**Liverpool John Lennon Airspace Change**

**ACP-2015-09**

**Stage 2 Develop and Assess**

**Step 2ai and Step 2aii- Options Development and Design Principle Evaluation Addendum**

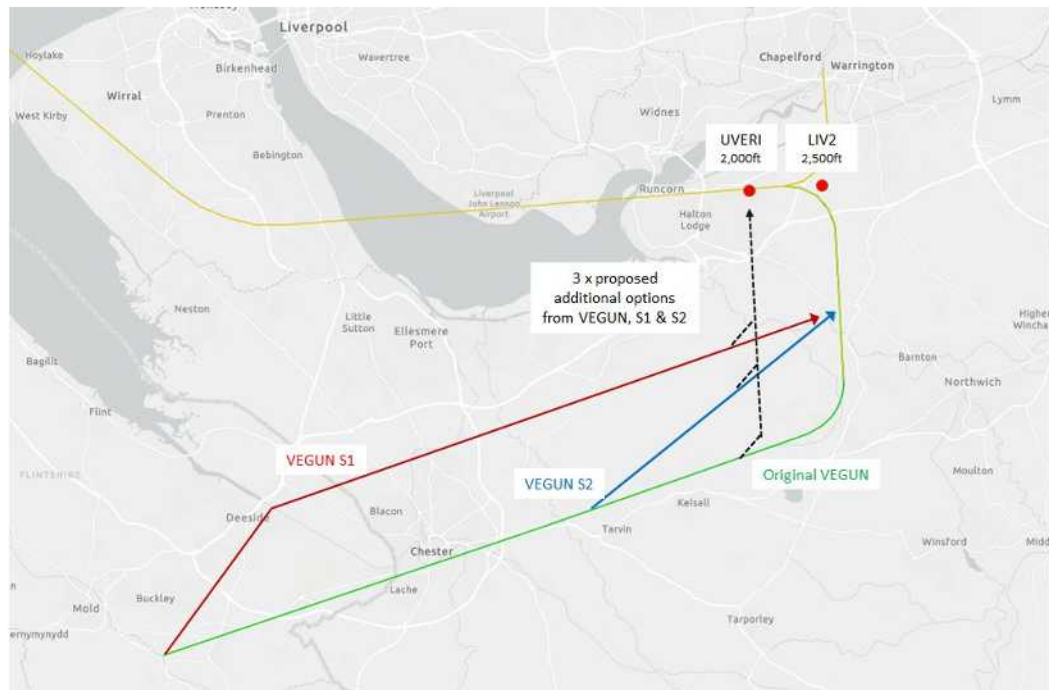
- 1.1. Create additional options for both VEGUN S1 and S2 transitions which require aircraft to be at 2,000ft before the base Leg turn.

This would have the effect of reducing the altitude of LPL traffic earlier, such that MAN Runway 23SW departures would only be required to be 3,000ft at approximately 5nm before the base leg track instead of 3,500ft. We would expect this to reduce the required climb gradient for MAN traffic to one that is achievable by all aircraft operating at MAN but further separation analysis work would be required to confirm this.

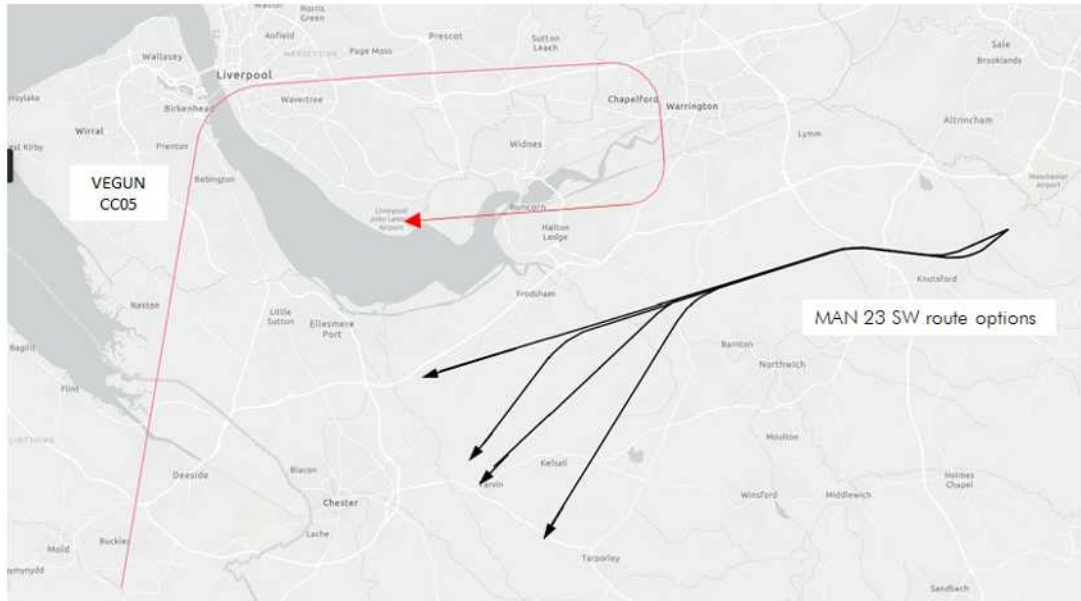
When MAN is operating on Runway 05 and LPL on Runway 27, an option was created by LPL in the designs previously advanced to Stage 4, presented as VEGUN CC05. This routes all LPL traffic from the south via VEGUN but in a right hand traffic pattern to the north of LPL. This option was created to resolve the potentially unsafe conflict created by the use of a left hand pattern to the south when MAN is using Runway 05 for arrivals. Further, this option replicates current operations albeit this scenario is infrequent because of the prevailing wind and proximity of the two airports.

Using this right hand transition more intensively, as the sole inbound route for all 27 arrivals from the south (i.e. all LPL from the south would route to VEGUN and transition to a right hand downwind pattern) should be included as an option. This would still allow a CDA to Runway 27 and would fully deconflict from all MAN SW departures. Because this route was included in the original submission, this does not require any additional design and the use of LPL downwind left hand arrivals could still be accommodated on a tactical basis following co-ordination with MAN.

#### 2.1. Create additional options for Runway 27 downwind RH transitions which require aircraft to be at 2,000ft before the base leg turn.

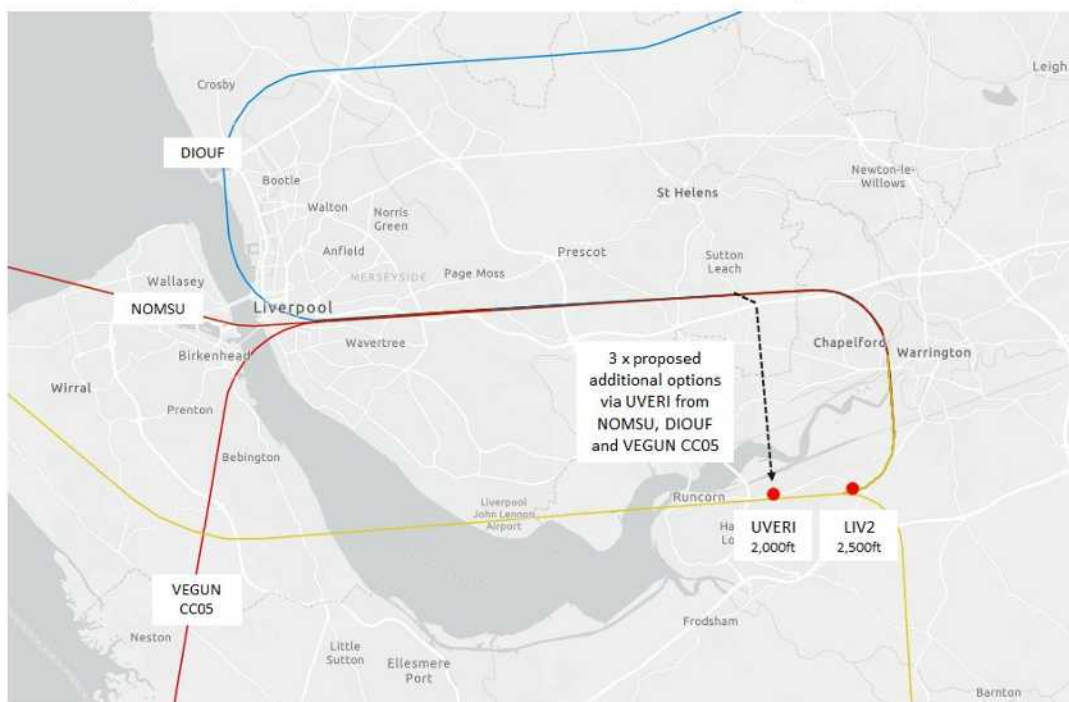
These options would have the effect of reducing the altitude of LPL traffic earlier, such that MAN Runway 23SW departures would only require to be 3,000ft 5nm before the base leg track. We would expect this to reduce the required climb gradient for MAN traffic to one that is achievable by a wider range of all aircraft operating at MAN but further separation analysis work would be required to confirm this.
